ADDENDUM NO. :	Three (3)
BID DUE TIME AND DATE:	2:00 p.m., April 30, 2019 (No Change)
BIDDER QUESTIONS BY:	11:59 a.m., April 23, 2019
LAST ADDENDUM ISSUED:	11:59 p.m., April 25, 2019

BID NUMBER: BID-SJR-06-2018
RENOVATION WITH ADDITION TO BUILDING V ST. AUGUSTINE CAMPUS

ST. JOHNS RIVER STATE COLLEGE

04/17/19 ADDENDUM 3

A101

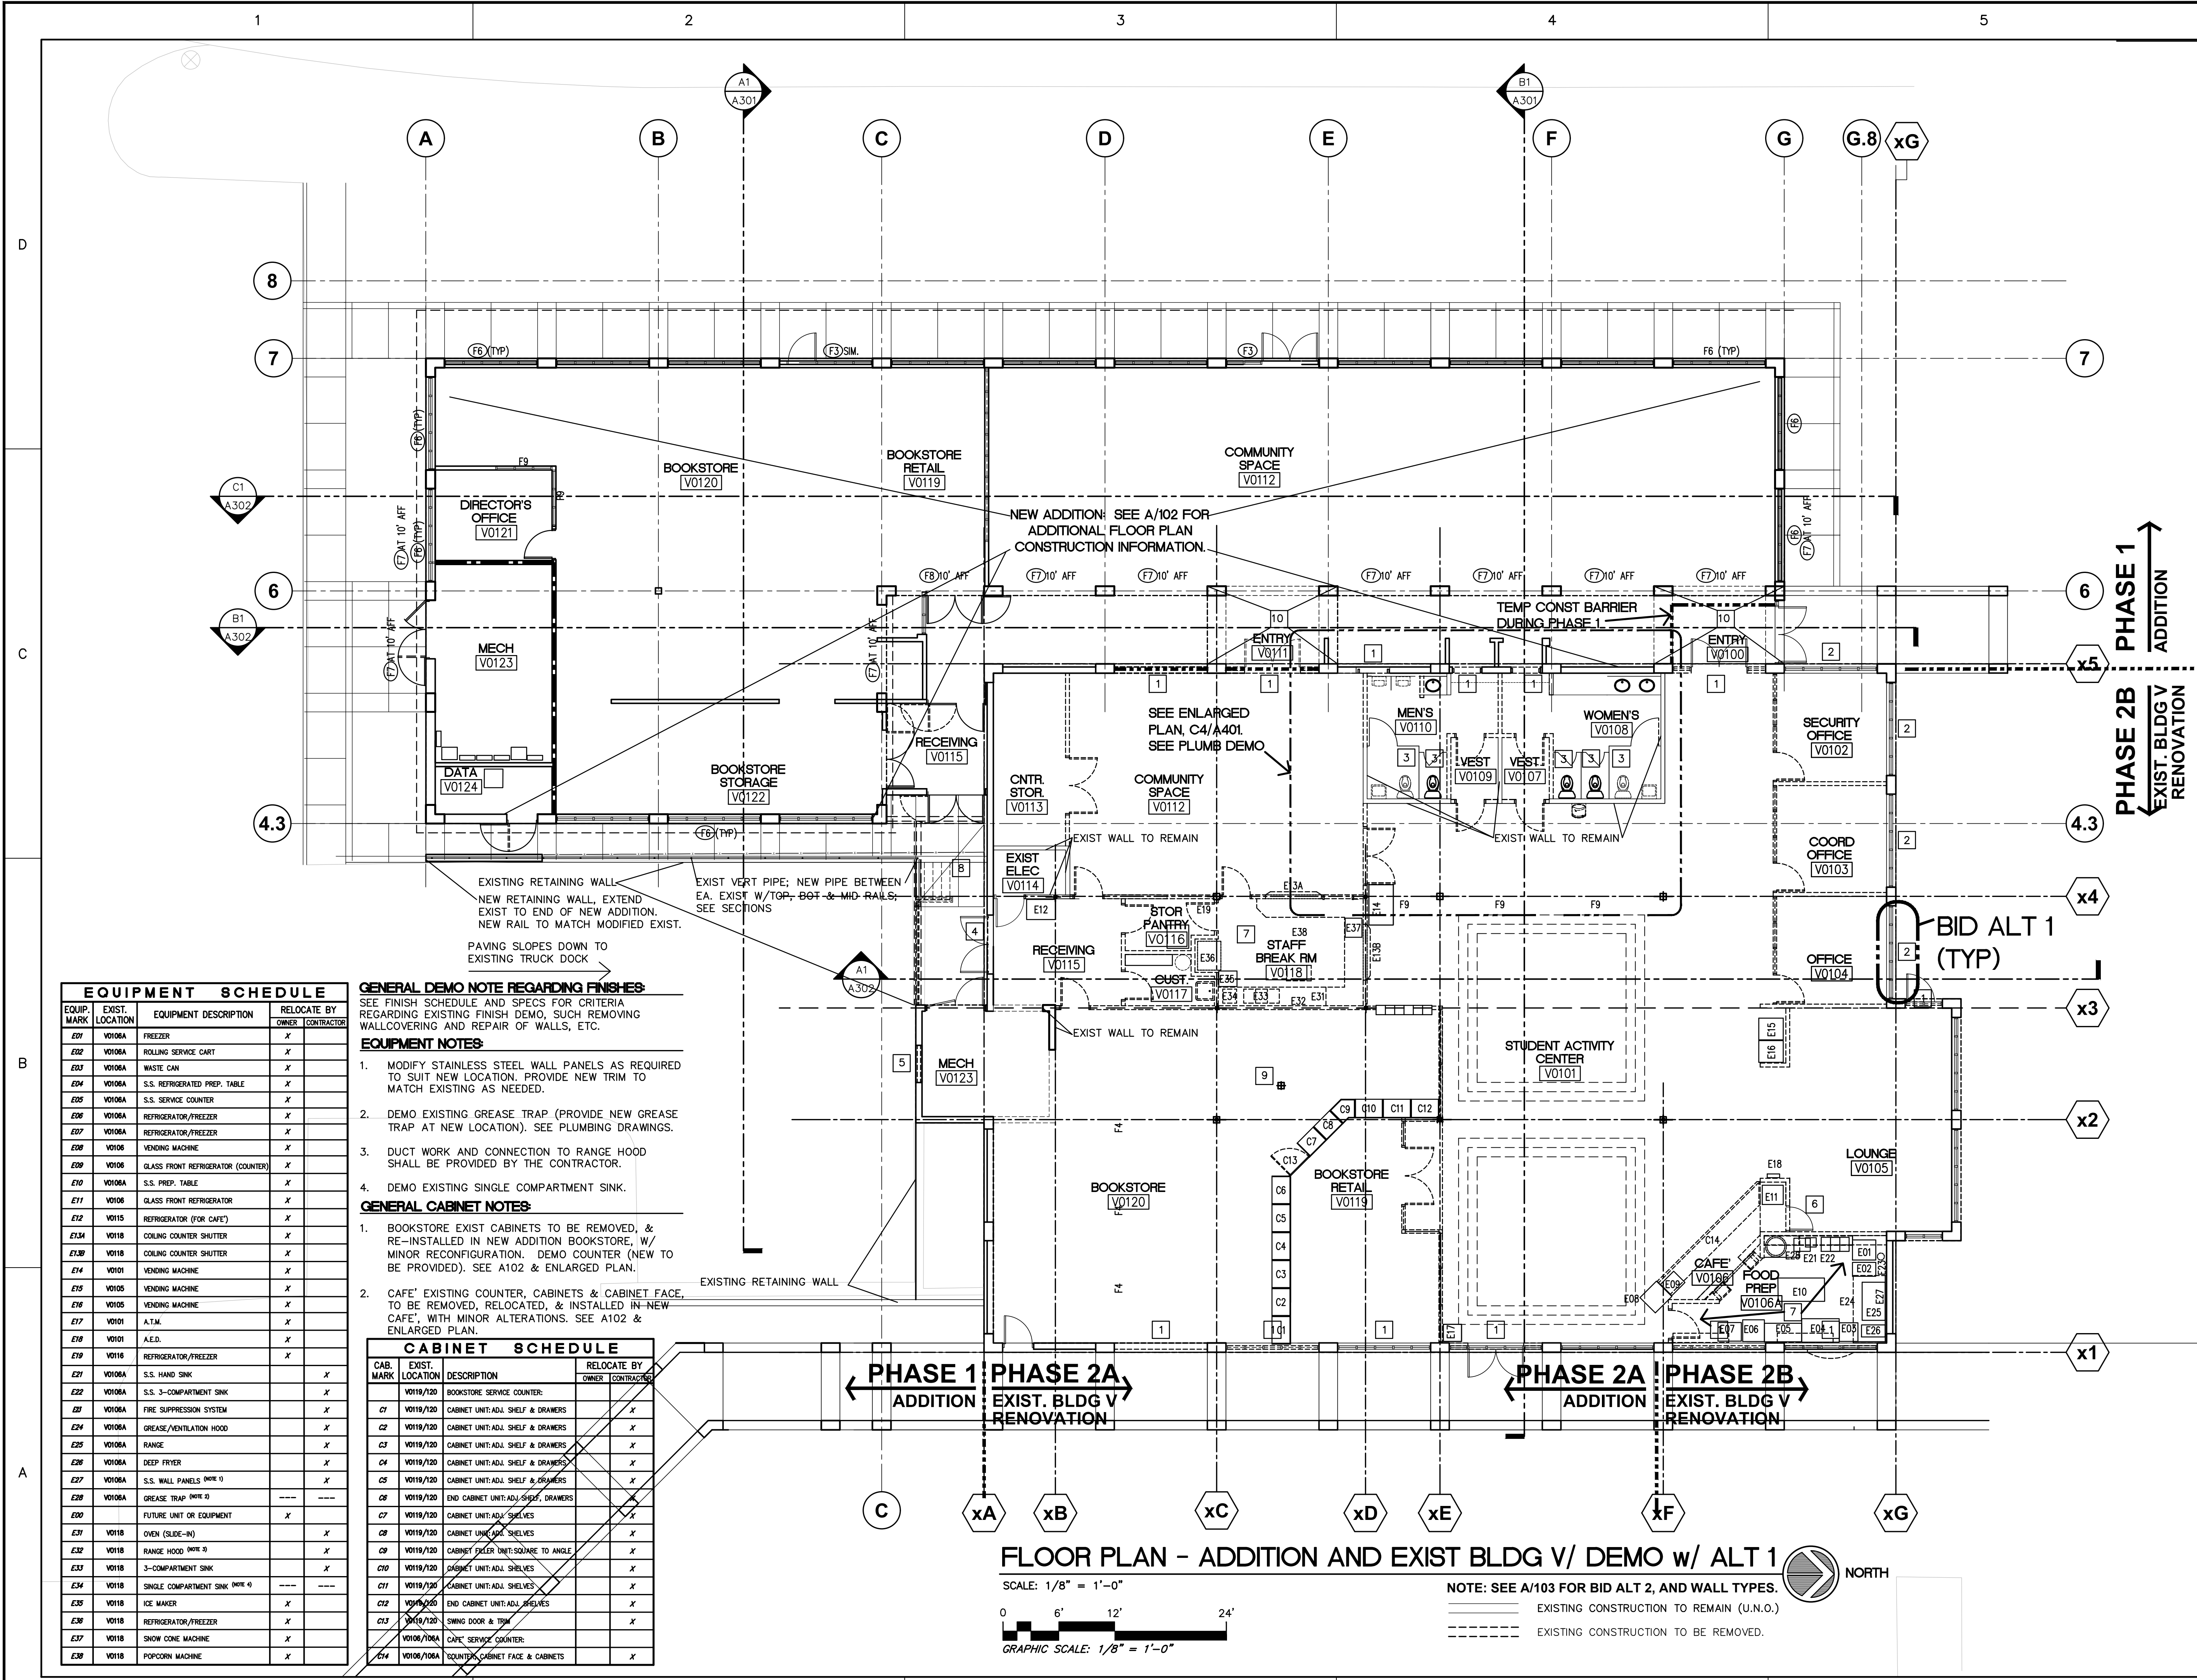
Interior Storefront Type identification: See Drawings A101, A102, A201, A202, A602

Aluminum storefront windows: Locations shown for aluminum storefront windows. Exterior for Addition shown on A101, including identifying the storefront at 10' AFF. Interior shown on A102 including identifying the storefront at 10' AFF. Also added Type F9, F10, and F11:

A202

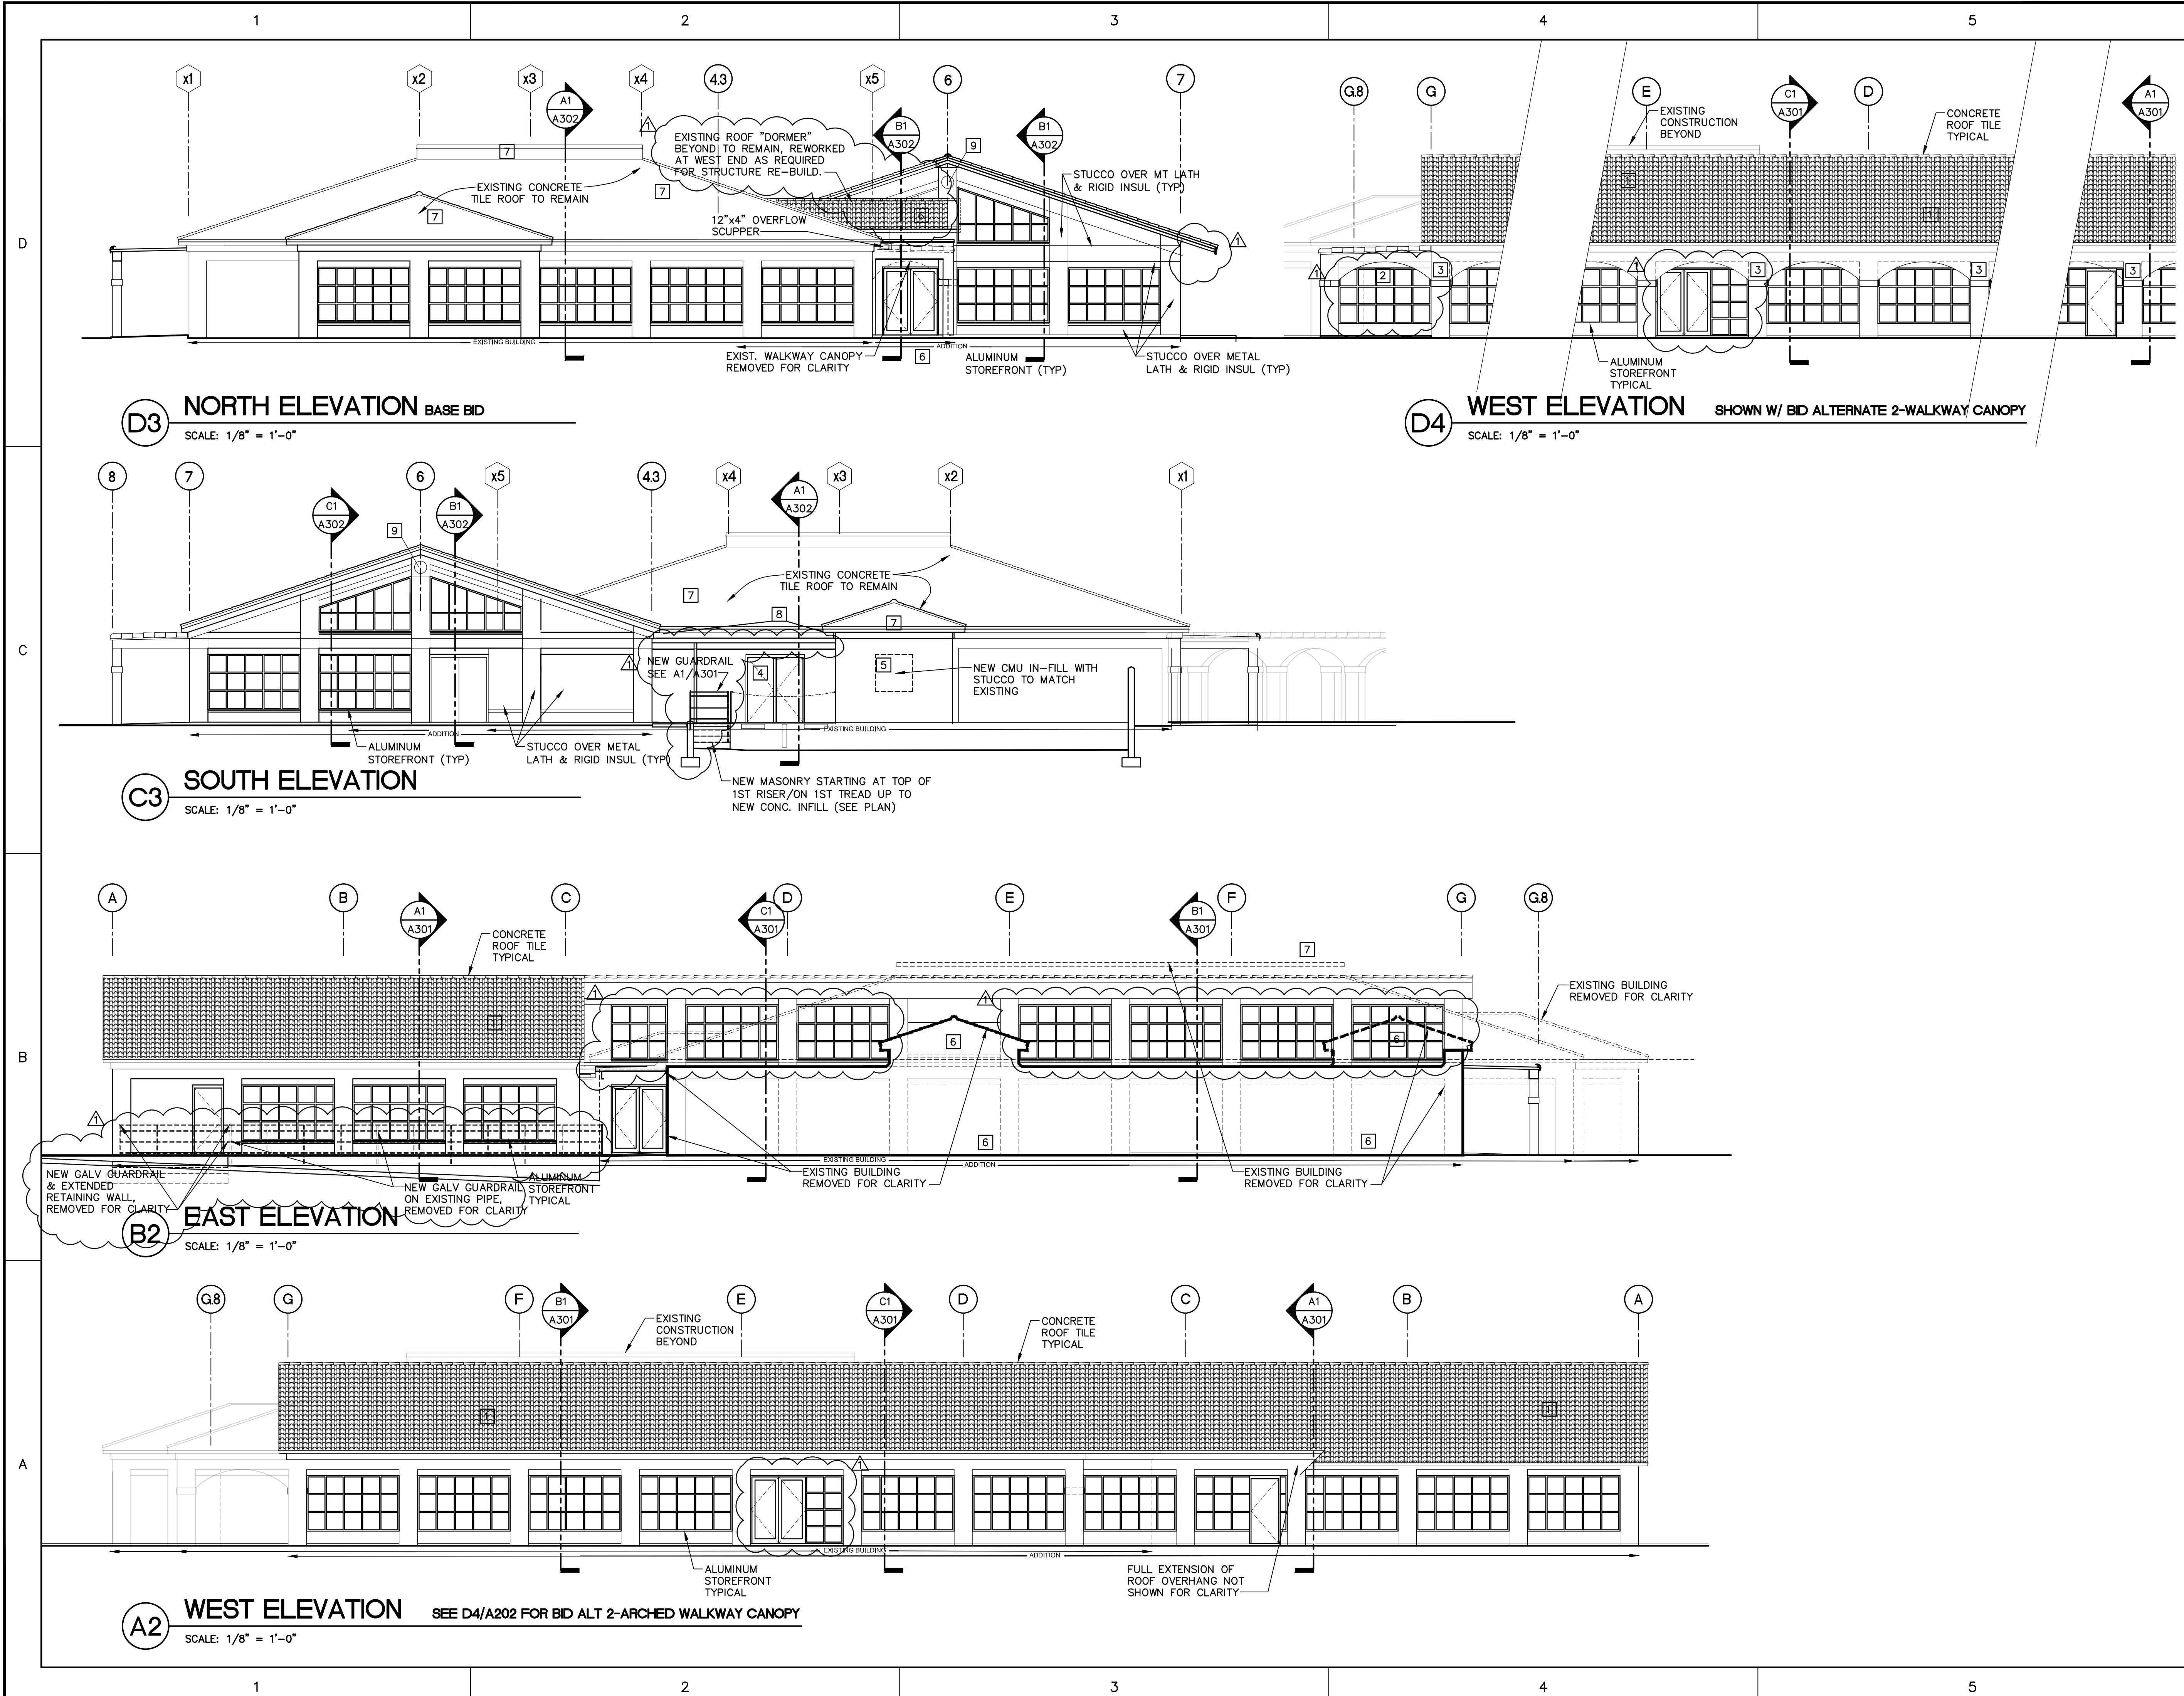
Canopy over Truck Dock: See Drawings A202, A301, A302, A303.

Revised to show low roof between Addition and Existing continuing east over Truck Dock (deleting reference to Pre-Fab Walkway Canopy). Repeating from Addendum 02: "Contractor Option" 6/S503 shows a change in elevation between main low roof and canopy accounting for no need for insulation (other than to provide slope); however can adjust the decks to be the same height and run the insul/mod bit system straight across to simplify construction.

- Entry door frames/F3 on A2/A202 shifting off-center,
- F6 and F8 Storefront height revised to reflect 6' height (above low roof) seen on B2/A202
- Triangular F7 visible on D3/A202

- On Elevation sheet, clarified locations where dormer being rebuilt, and removed gutter and angled downspout incorrectly shown on right end (west end) of D3/A202.
